F²MC-16LX Standby Cancel Failure

1. Summary

Figure 3: Timing chart of entering/leaving Standby mode in case of failure

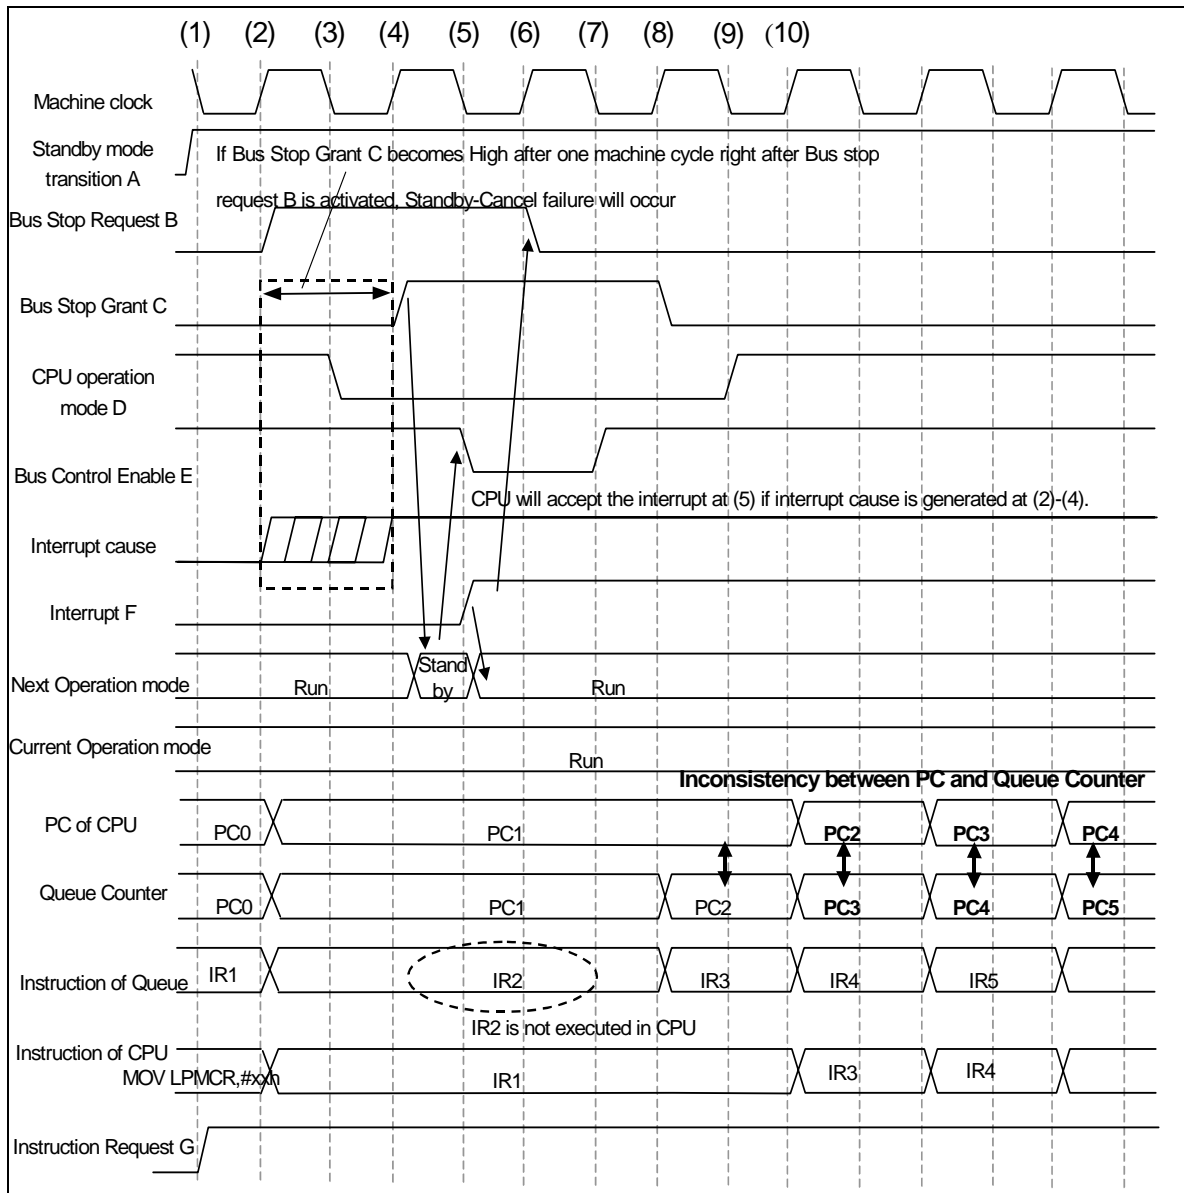
(4)	Bus Control Unit accepts Bus Stop Request and Bus Stop Grant C becomes High => Next Operation mode becomes Standby mode	
(5)	Operation Mode Control sets Bus Control Enable E to Low => Bus Control Unit is stopped Interrupt F becomes High according to interrupt cause at time (2)-(4) => Next Operation mode becomes CPU RUN mode This is the actual cause of the Standby Cancel failure.

(7)	Operation Mode Control Unit sets Bus Control Enable E to High => Bus Control Unit restarts operation	
(8)	Bus Stop Grant C becomes Low because Bus Control Unit accepted the cancellation of Bus Stop Request => Queue Counter starts counting, though CPU is stopped, because Instruction Request G becomes High. As a result, Instruction of Queue changes to IR3 before execution of instruction IR2. A definition of Standby Cancel Failure is this phenomenon.

(9)	Operation Mode Control Unit sets CPU Operation mode D to High => CPU restarts operation	
(10)	After this, PC of CPU starts, but Queue Counter in Bus Control Unit is one count ahead of the PC of CPU. Therefore the IR3 instruction is executed instead of the IR2 instruction. As a result, MCU does not run correctly until Queue Counter is updated with the value of the PC.

Figure 4: Timing chart of entering/leaving Standby mode with software workaround (1)

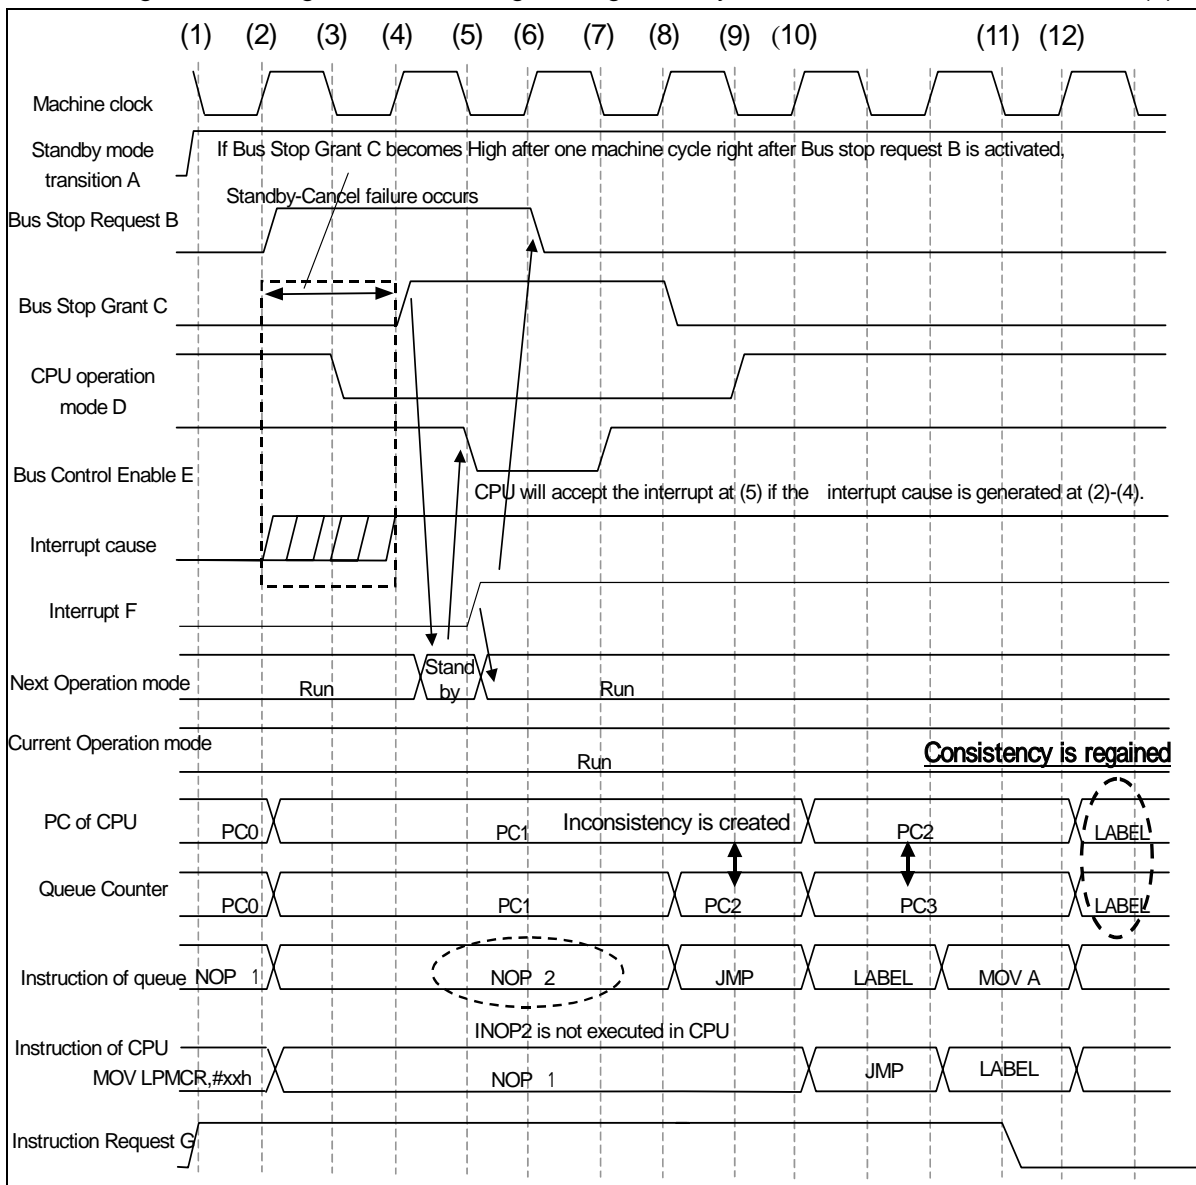
If the interrupt does not cause the execution of an interrupt service routine*7 and the instruction after the Standby mode transition instruction is executed, the Standby Cancel Failure can be solved with the software workaround as defined in the dotted line frame. Figure 4 shows the corresponding timing chart.

(9)	Operation Mode Control Unit sets CPU Operation mode D to High => CPU restarts operation	
(10)	After this, PC of CPU starts but the Queue Counter in Bus Control Unit is one count ahead of the PC of the CPU. Therefore, the JMP instruction is executed instead of NOP2. NOP2 is not executed, but this is no problem.

(PC0) MOV LPMCR,#xxh ;Standby mode transition instruction
(PC1) NOP           ;NOP 1
(PC2) NOP           ;NOP 2
(PC3) JMP LABEL
LABEL:
      MOV A,#010H   ;Application

(11)	Instruction Request G becomes Low because this instruction is JMP	
(12)	Since by this jump instruction the Queue Counter value is updated with the PC value, the consistency between the Queue Counter and the PC of the CPU is regained. After this, the MCU runs correctly.

Figure 5: Timing chart of entering/leaving Standby mode with software workaround (2)

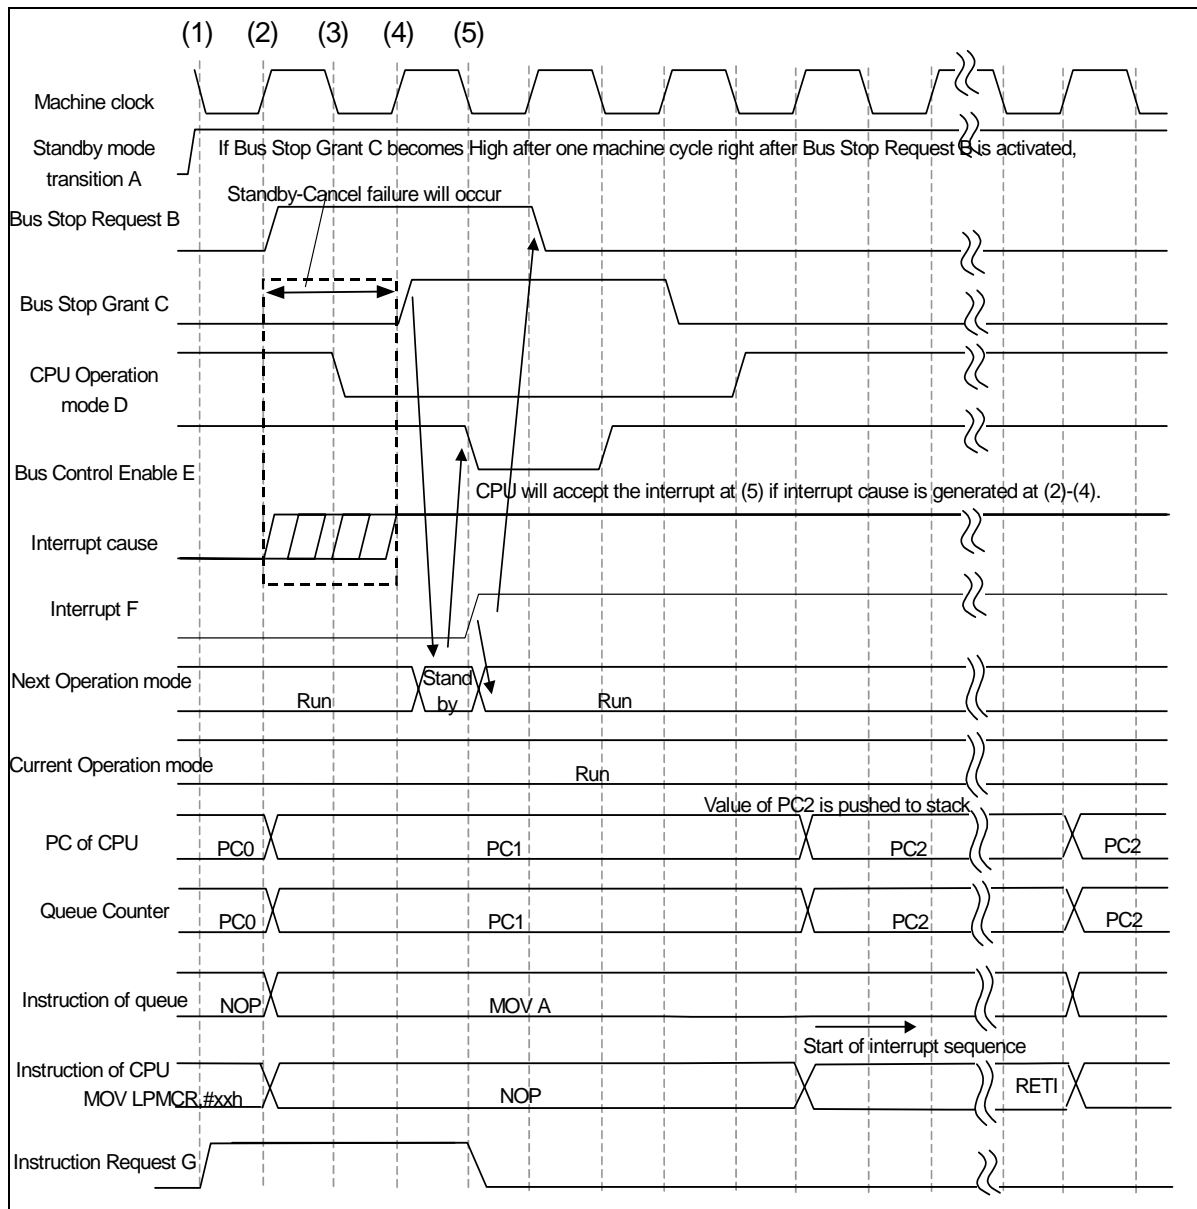
If the interrupt causes the execution of an interrupt service routine *8 and the next instruction after the Standby mode transition instruction (enclosed by the dotted line frame) is an one-cycle instruction from table 3, the Standby Cancel Failure can be solved. Figure 5 shows this timing chart.

Timing	Operation	Interrupt
(1)	Standby mode transition A becomes High with the execution of Standby mode transition instruction (MOV LPMCR, #xxh) => Transition to Standby mode starts.	
(2)	Operation Mode Control Unit sets Bus Stop Request B to High => Bus Control Unit accepts Bus Stop Request	Interrupt cause ↑ ↓
(3)	Operation Mode Control Unit sets CPU Operation mode D to Low => CPU is stopped	
(4)	Bus Control Unit accepts Bus Stop Request and Bus Stop Grant C becomes High => Next Operation mode becomes Standby mode	
(5)	Operation Mode Control Unit sets Bus Control Enable E to Low => Bus Control Unit is stopped Interrupt F becomes High according to interrupt cause at (2)-(4) => Next Operation mode becomes CPU RUN mode but Instruction Request G is masked by Interrupt F. In this case, since Instruction request G becomes Low, Standby-Cancel failure does not occur.

Figure 6: Timing chart of entering/leaving Standby mode with software workaround (3)

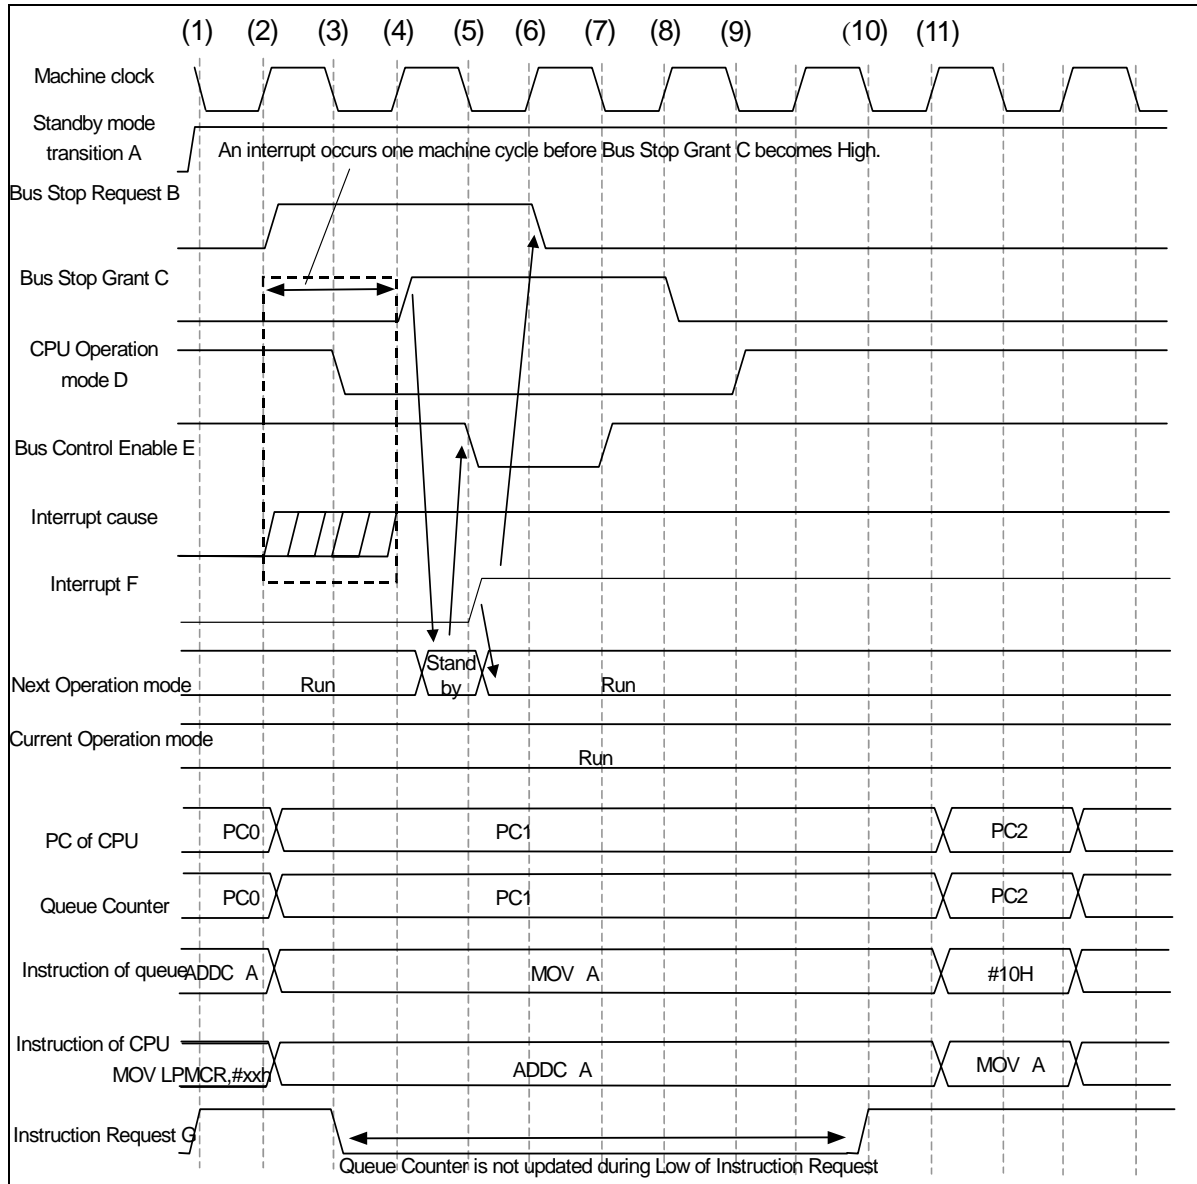
If there is an instruction that is defined in Table 2 right after Standby mode transition instruction, Standby-Cancel Failure does not occur as Figure 6 shows.

(PC0)	MOV LPMCR,#xxh	;Standby mode transition instruction
(PC1)	ADDC A	;Instruction which Queue counter is not updated, please see Table 2.
(PC2)	MOV A,#010H	;Application

(7)	Operation Mode Control Unit sets Bus Control Enable E to High => Bus Control Unit restarts operation	
(8)	Bus Stop Grant C becomes Low because Bus Control Unit accepted the cancellation of Bus Stop Request => Since Instruction Request is low, the Queue Counter is not updated while the CPU is stopped. As a result, the Standby-Cancel failure does not happen.

6.7 Flowchart to decide whether Standby-Cancel problem affects existing software

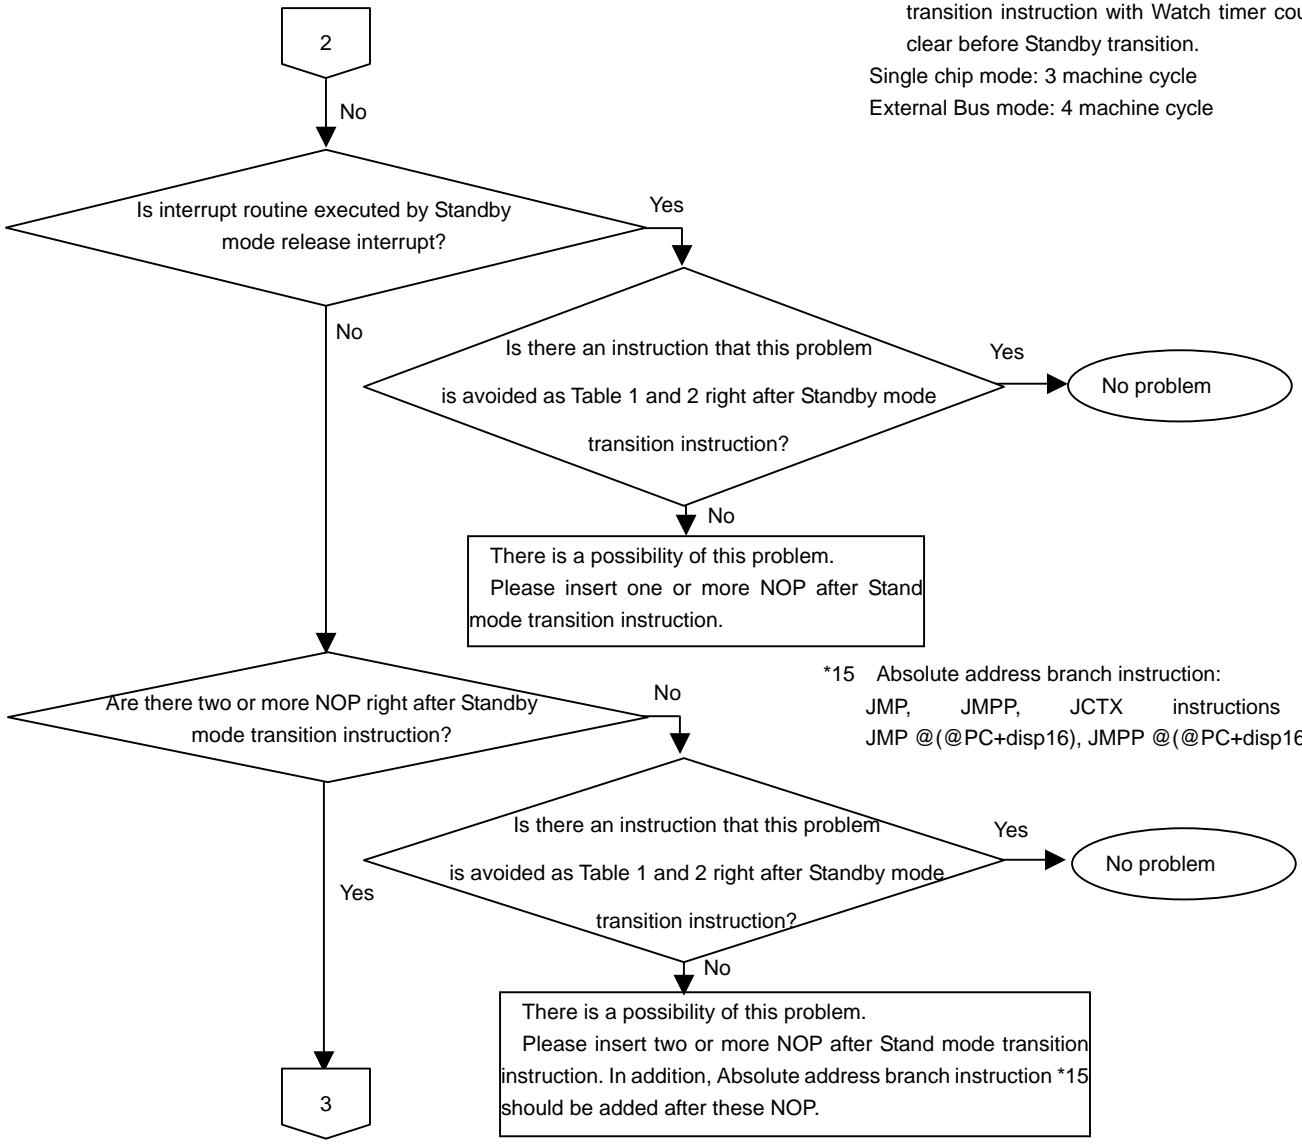
*14 Watch timer interrupt is one example.
 In this case, No interrupt may occur during 3 or 4 machine cycle after executing a Sleep mode transition instruction with Watch timer counter clear before Standby transition.
 Single chip mode: 3 machine cycle
 External Bus mode: 4 machine cycle

*15 Absolute address branch instruction:
 JMP, JMPP, JCTX instructions except
 JMP @(@PC+disp16), JMPP @(@PC+disp16)
